ARCHITECTURAL REVIEW BOARD STAFF REPORT

Project #/Name	ARB-2021-27: 999 Rio Road Final Site Plan
Review Type	Final Site Development Plan
Parcel Identification	06100-00-00-154B0
Location	At the east corner of the intersection of Rio Road and Belvedere Boulevard. (See Figure 1.)
Zoned	Neighborhood Model District (NMD)/Entrance Corridor (EC)
Owner/Applicant	Windmill Ventures LLC/Shimp Engineering (Justin Shimp)
Magisterial District	Rio
Proposal	To construct the first phase of a mixed-use development including multi-family attached and single-family attached and detached residential units, with associated site improvements. A 5,000-sf office building is planned for Phase 2.
Context	The subject parcel is comprised of a ca. 1960 residence and associated outbuildings and wooded area. In the immediate vicinity on the Entrance Corridor is a mix of large-scale institutional development (Covenant Church to the northwest and CATEC to the southwest) and single-family detached residential development (Dunlora, two- to three-stories) to the south and east. Single-story commercial development is found on the north side of the corridor just west of the railroad tracks, with residential on the sout

Figure 3: Initial Site Plan reviewed by the ARB on July 6, 2020.

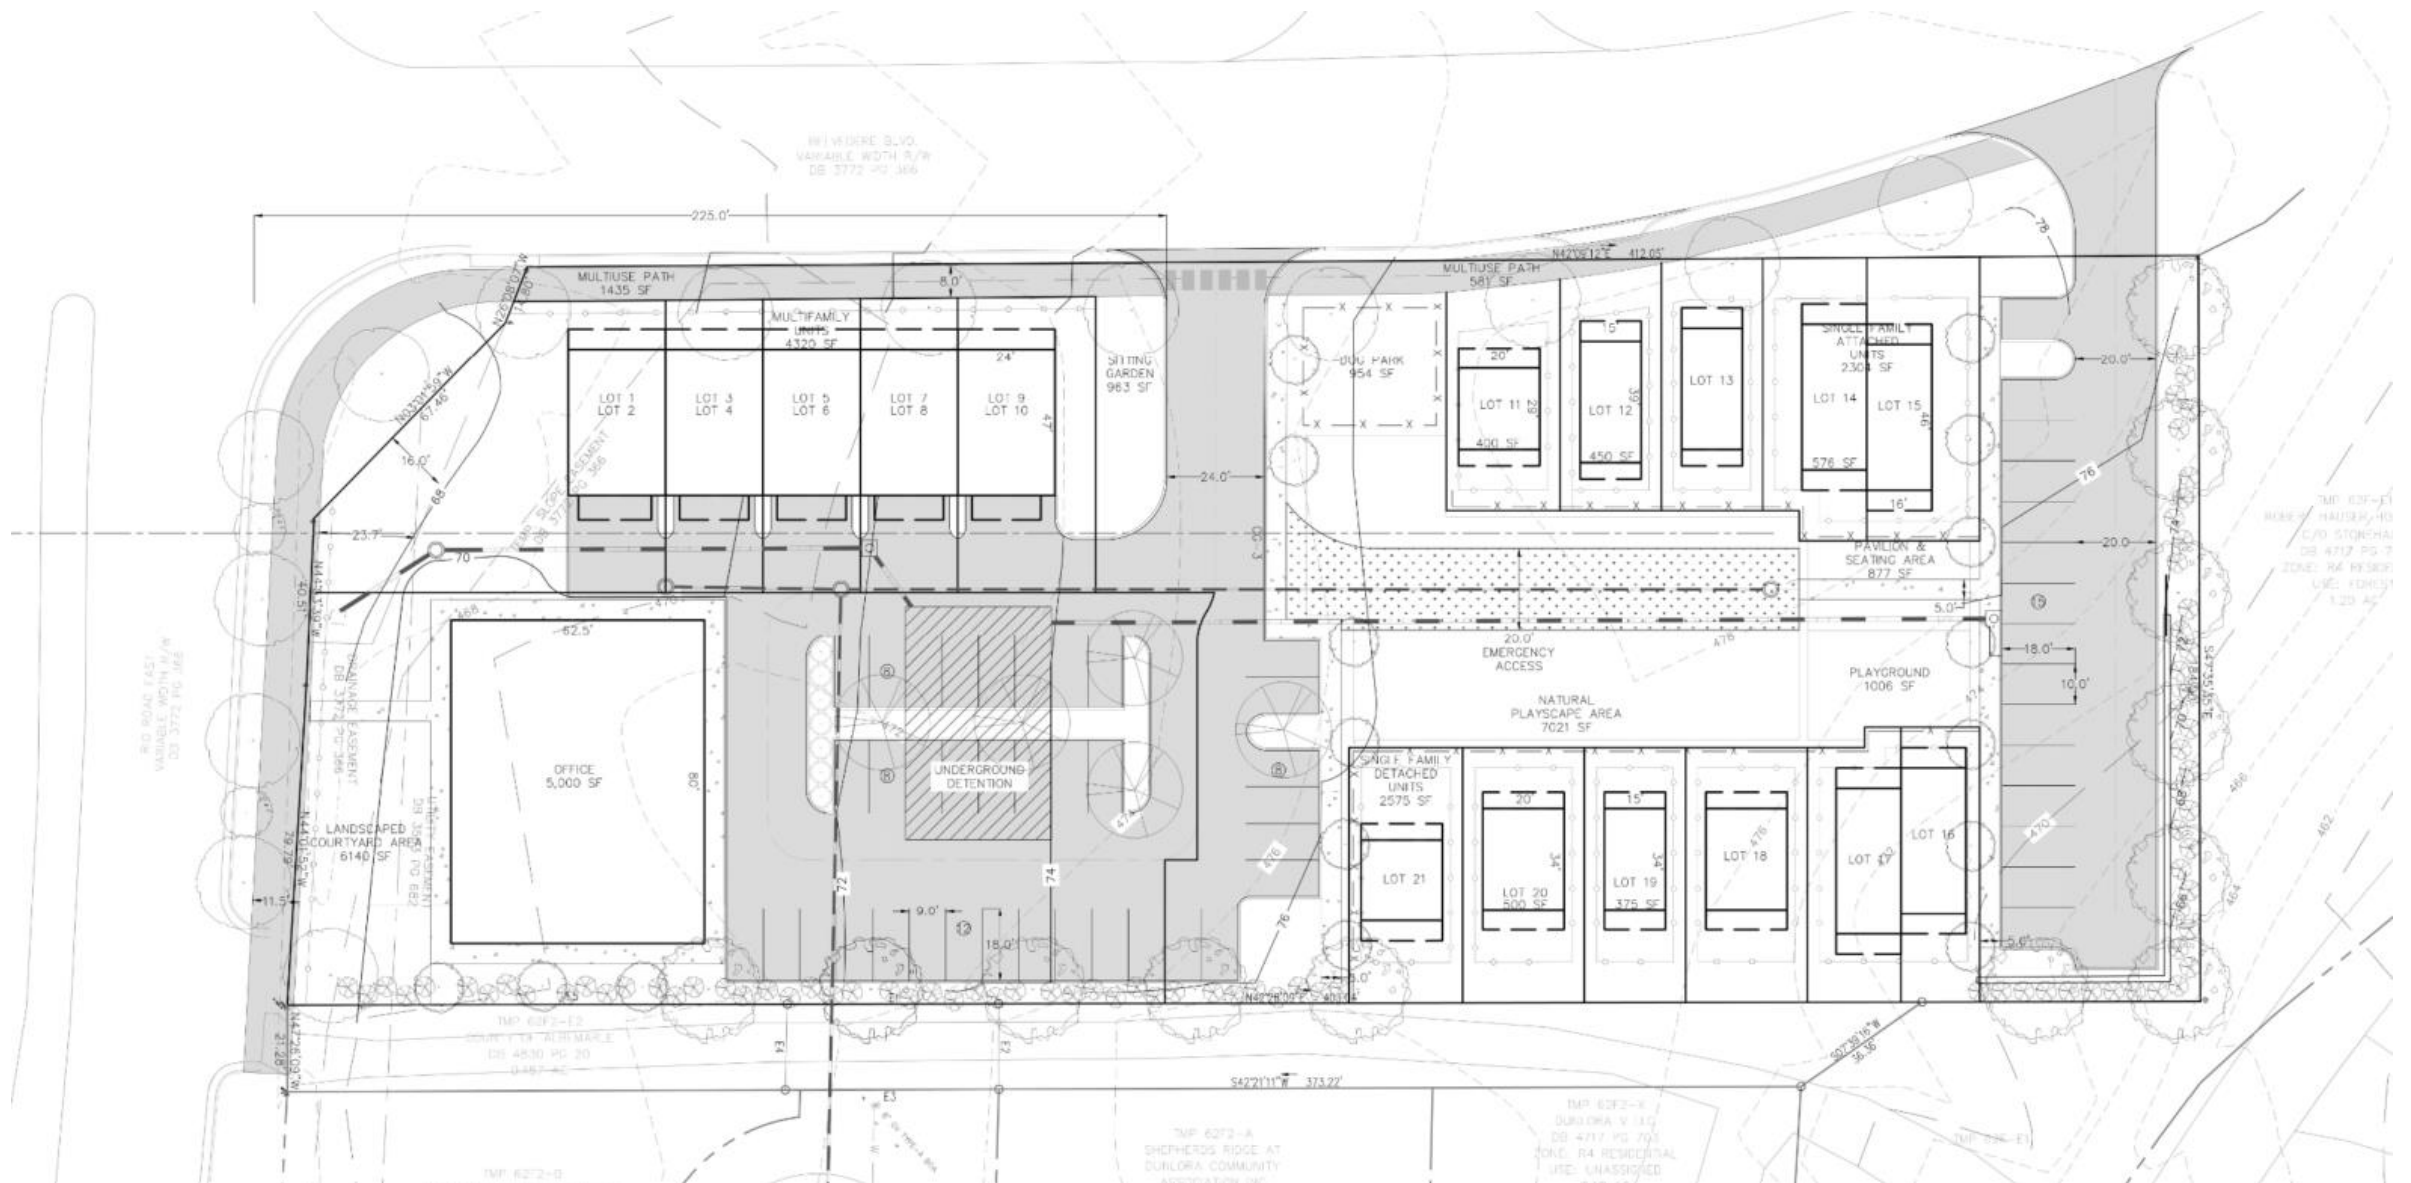
The ARB reviewed the initial site plan for this proposal on July 6, 2020. (See Figure 3.) Comments from that meeting are included in the Analysis section of this report. The attached units are distributed differently than in the previous plan and the detached units are now all located in a row at the east end of the south side of the site. Parking between the office site and the attached units has been extended closer to Rio Road. The sitting garden and dog park have swapped locations near the central Belvedere Blvd. entrance. A dumpster has been added at the southeast corner of the parking lot. The retaining wall at the southeast corner of the site has been extended further west.
